COVER SHEET  
CIVIL PLANS

240 15TH STREET SE  
PUYALLUP, WA 98372

**FORTRESS - PUYALLUP**

PORTION OF SE QUARTER OF SEC 27, TWN 20 N, RGE. 4 E, W.M.  
CITY OF PUYALLUP, PIERCE COUNTY, WASHINGTON  
**WATER AND SANITARY SEWER PLAN**

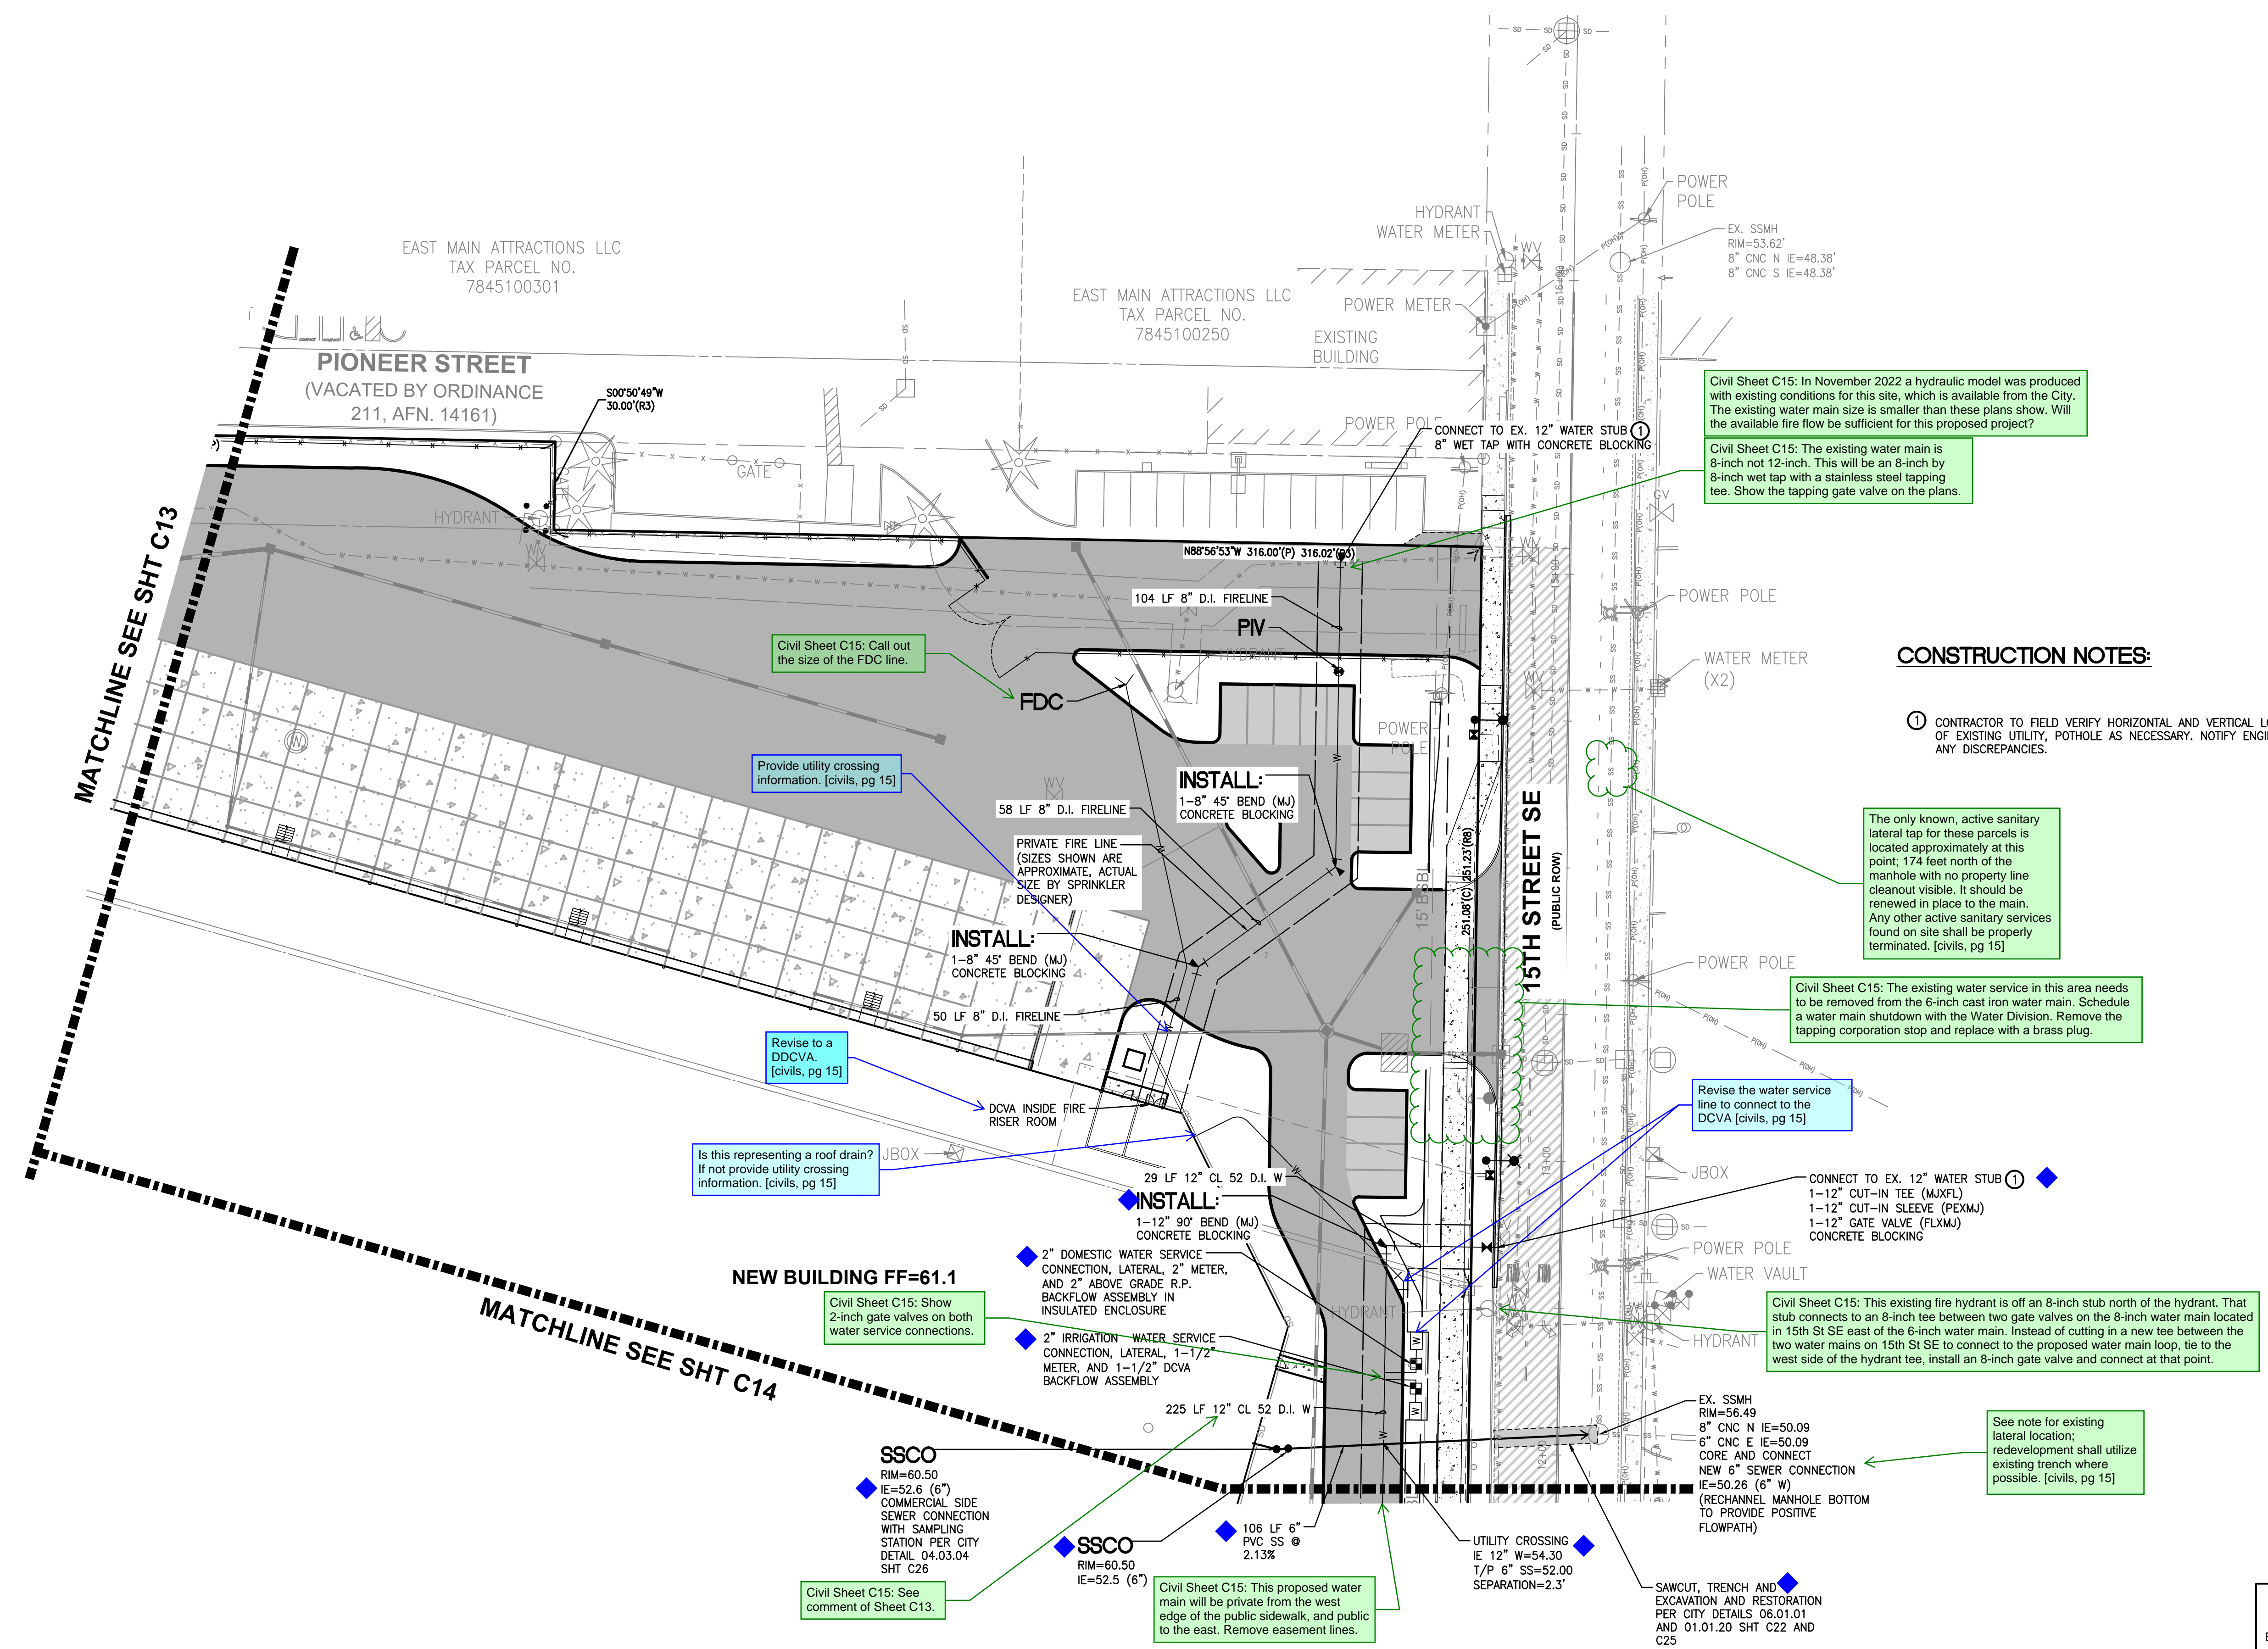
Civil Sheet C15: The existing water service in this area needs to be removed from the 6-inch cast iron water main. Schedule a water main shutdown with the Water Division. Remove the tapping corporation stop and replace with a brass plug.

Civil Sheet C15: This existing fire hydrant is off an 8-inch stub north of the hydrant. That stub connects to an 8-inch tee between two gate valves on the 8-inch water main located in 15th St SE east of the 6-inch water main. Instead of cutting in a new tee between the two water mains on 15th St SE to connect to the proposed water main loop, tie to the west side of the hydrant tee, install an 8-inch gate valve and connect at that point.

PORTION OF SE QUARTER OF SEC 27, TWN 20 N, RGE. 4 E, W.M.  
CITY OF PUYALLUP, PIERCE COUNTY, WASHINGTON  
**FRONTAGE IMPROVEMENT PLAN**

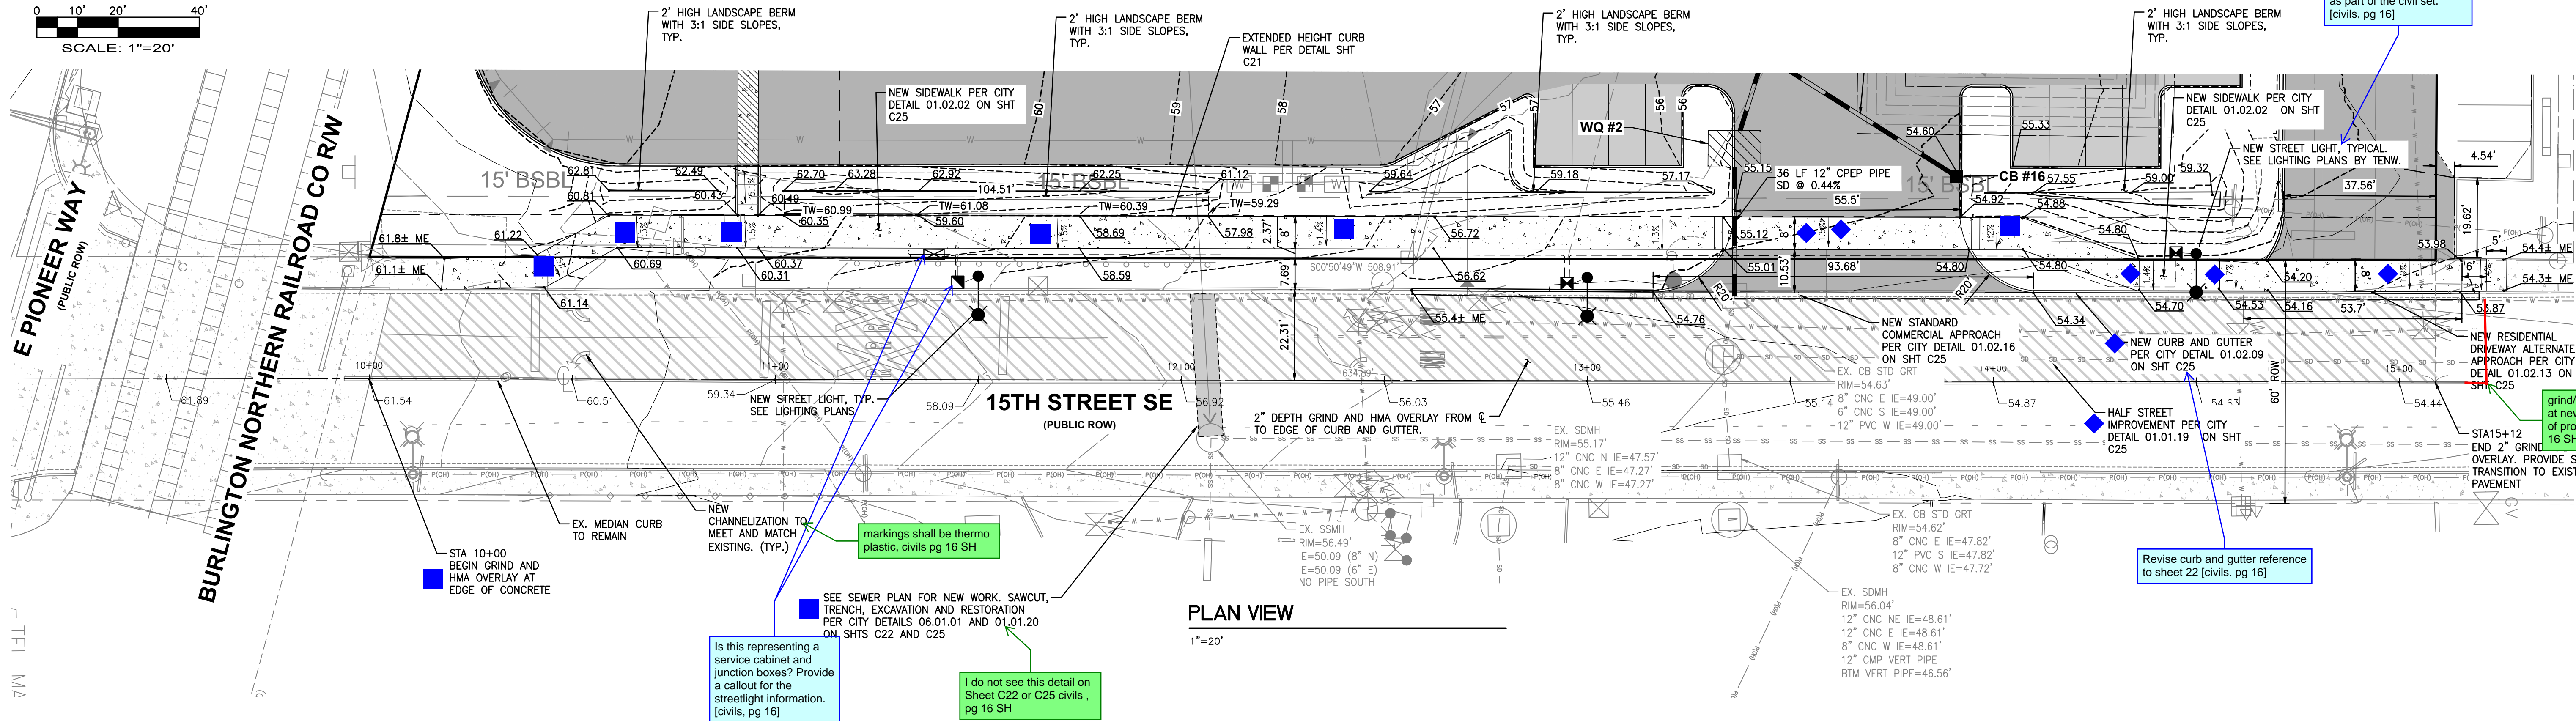
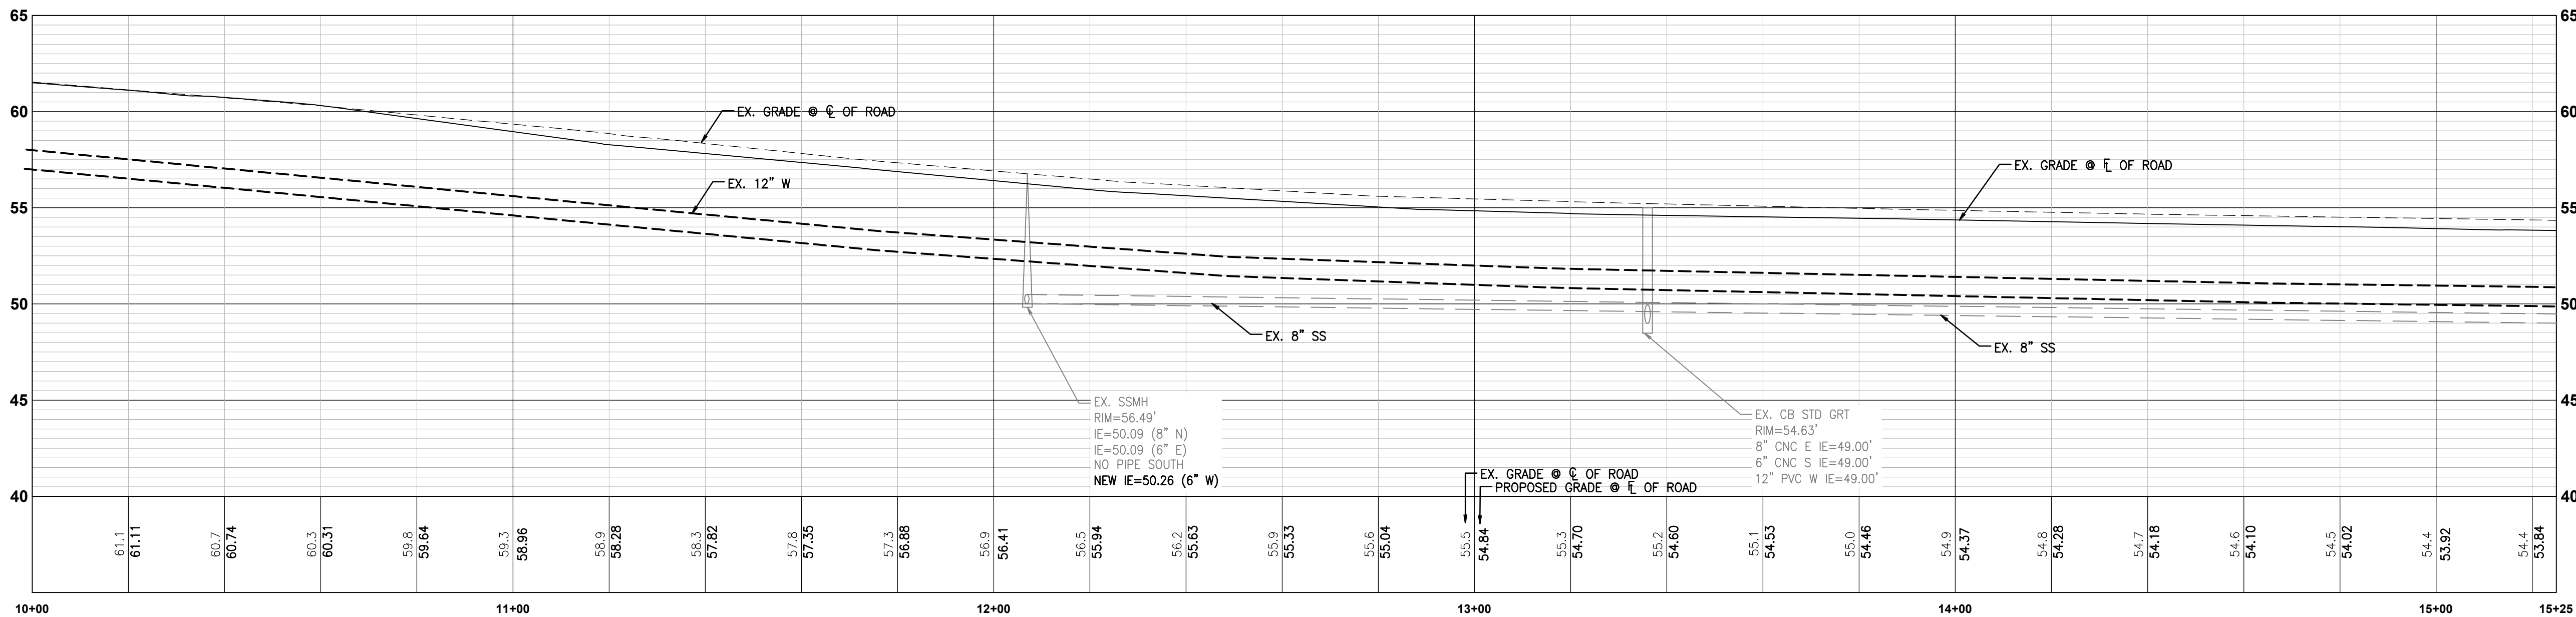
Revise curb and gutter reference to sheet 22 [civils, pg 16]
